SERVICE BULLETIN NO: 53-005

MODIFICATION NO: ECN 04-0416

## FUSELAGE - FUSELAGE STRUCTURE INSPECTION FOR CORROSION IN FRAMES 3C AND REPLACEMENT OF WING ATTACHMENT BOLTS

FR 3C Assembly - Inspection and Replacement of Bolt Assembly  
Figure 1

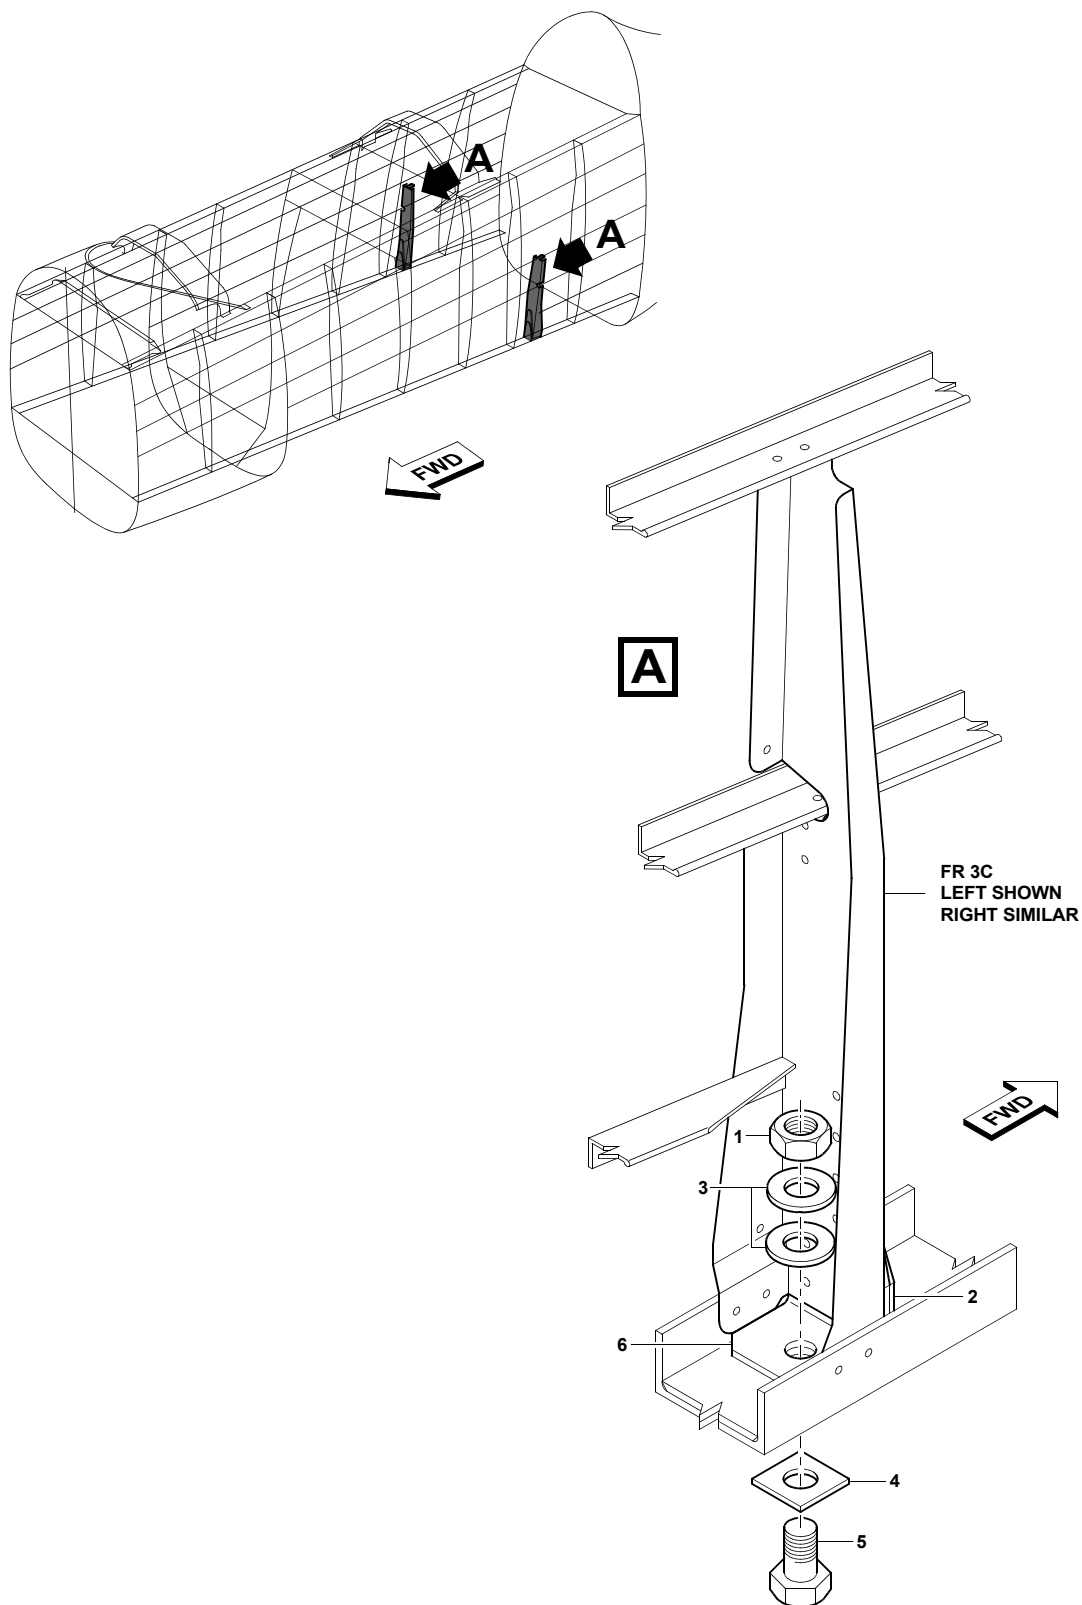
Corrosion has occurred in the pick-up brackets (brackets) (553.20.09.039) of Frame (FR) 3C in some aircraft. The brackets connect FRs 3C to the bottom, left and right longerons. They are also the locations for the wing bolts (bolts) (932.19.60.337).

Electrolytic action between the dissimilar metals of the bolts (932.19.60.337) and the brackets (553.20.09.039) has caused the corrosion.

- (a) Do inspections of the FR3C assemblies and adjacent structure for signs of corrosion
- (b) Replace the wing, rear attachment bolt assemblies with cadmium plated bolts. This will help to prevent corrosion in the applicable items
- (c) If necessary replace the FR3C assemblies and attaching parts.

- (1) Remove and discard the left nut (1), washers (3) & (4) and bolt (5).
- (2) Obey the manufacturers instructions and use the solvent (Material Item No. P01-008 or approved alternative) to clean the surfaces of hole for the bolt (1).
- (3) Use a source of bright light and a X 10 magnifier to do an inspection for signs of corrosion:
  - In the hole for the bolt (1)
  - On the bracket (6), shear plate (2), FR 3C and the adjacent structure.

Corrosion is not permitted in the bolt holes. Surface corrosion on the bracket, shear plate or FR 3C assembly is permitted if in limits (Ref. SRM, 53-20-00, Page Block 101). All other types of corrosion in the bracket, shear plate, FR 3C or the adjacent structure is not permitted. You must:

- Remove surface corrosion (Ref. Step 4)
  - Replace the bracket, shear plate and FR 3C assembly together if you find corrosion in one or more of them (Ref. SRM, 53-20-00, Page Block 201):
  - Apply to PILATUS for instructions if you find corrosion in the skin or structure adjacent to FR 3C.
- (4) If necessary remove the surface corrosion (Ref. SRM, 51-10-02, Page Block 1). You must replace the bracket, shear plate and FR 3C assembly (together) if it is not possible to remove the surface corrosion and stay in limits.
  - (5) Obey the manufacturers instructions and apply layers of the corrosion preventative (Material Item No. P04-012) on the faying surfaces of the new bolt (5), washers (3) & (4) and the bolt hole.
  - (6) Assemble the bolt (5) and washer (4), put the bolt in position and install the washers (3) and nut (1).

- (7) Torque the nut (1) to between 26 and 28 Nm (230 to 248 lbf in.).
- (8) Obey the manufacturers instructions and use the solvent (Material Item No. P01-008 or approved alternative) to remove unwanted corrosion preventative.
- (9) Apply layers of the corrosion preventative (Material Item No. P10-015) on the FR 3C assembly and adjacent skin and structure.
- (10) Do Steps (1) thru (9) again to:
  - Do an inspection for corrosion in the right bolt hole, bracket (5), shear plate (6), FR 3C and the adjacent structure.
  - Replace the right bolt assembly
